3. Zoning By-Law Amendment – 151 Chapel Street
Modification au Règlement de Zonage – 151, rue Chapel

File Number: ACS2019-PIE-PS-0093

SUBJECT: Zoning By-law Amendment – 151 Chapel Street

151 Chapel Street

Schedule 354 to Zoning By-law 2008-250

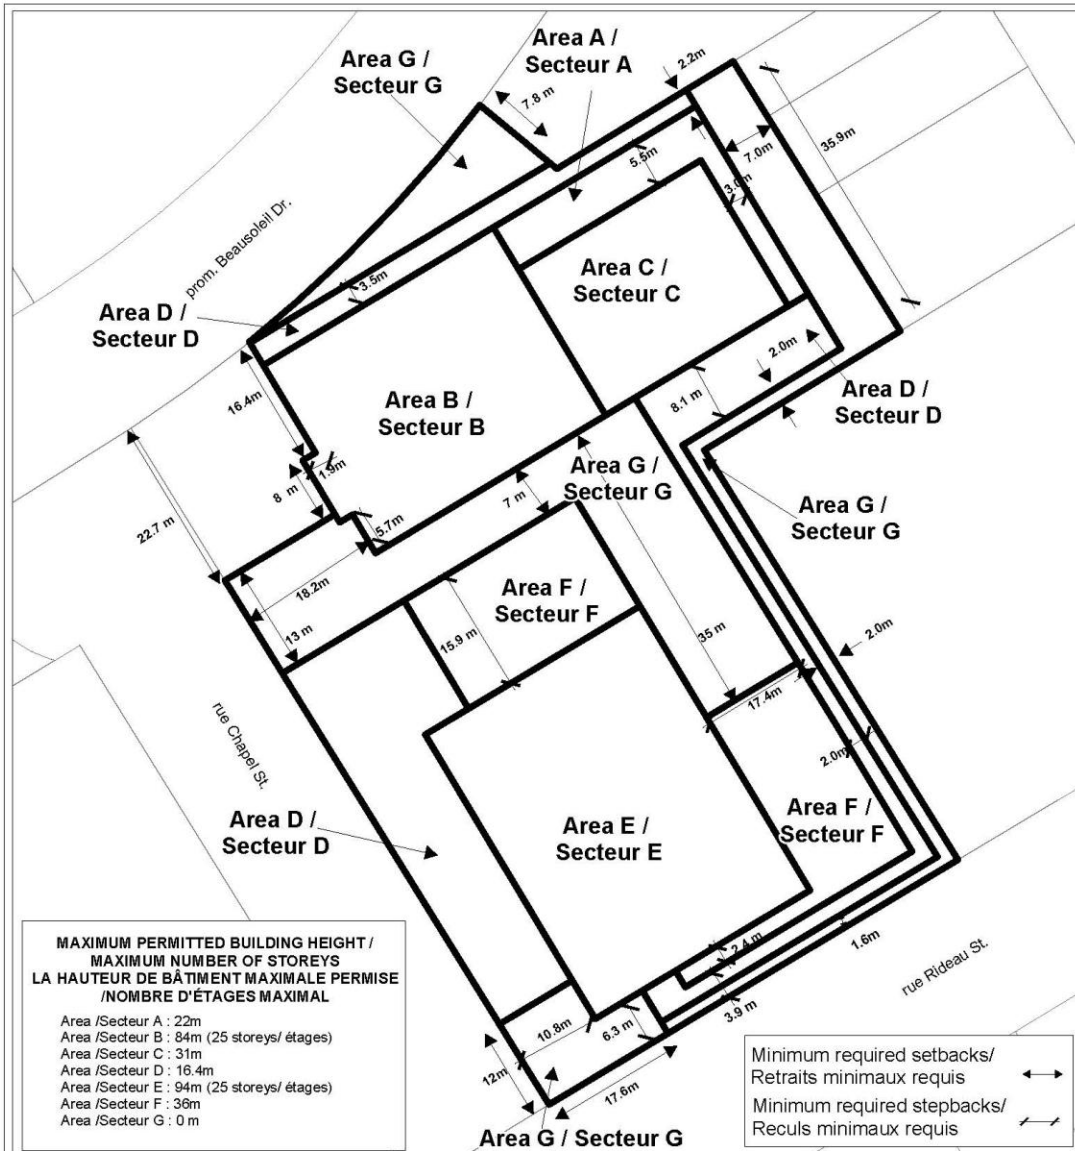
1. Rezone the lands shown in Document 1, Map 1 as follows:
 - a) Amend Schedule 354 as attached.
2. Amend the exception 2339 to Section 239, Urban Exceptions, with provisions similar in effect to the following:

- a) In Column V, amend the text to remove the following:
 - Within Area B on Schedule 354 and above the eighth storey, the maximum permitted floor plate size is 925 square metres

- Within area E on Schedule 354 and above the eighth storey, the maximum permitted floor plate size is 925 square metres
 - Despite Schedule 354, no portion of the first and second storey of the building, with the exception of supporting columns, may be closer to the northernmost lot line than 22 metres for a minimum of 21.5 metres from the western most lot line
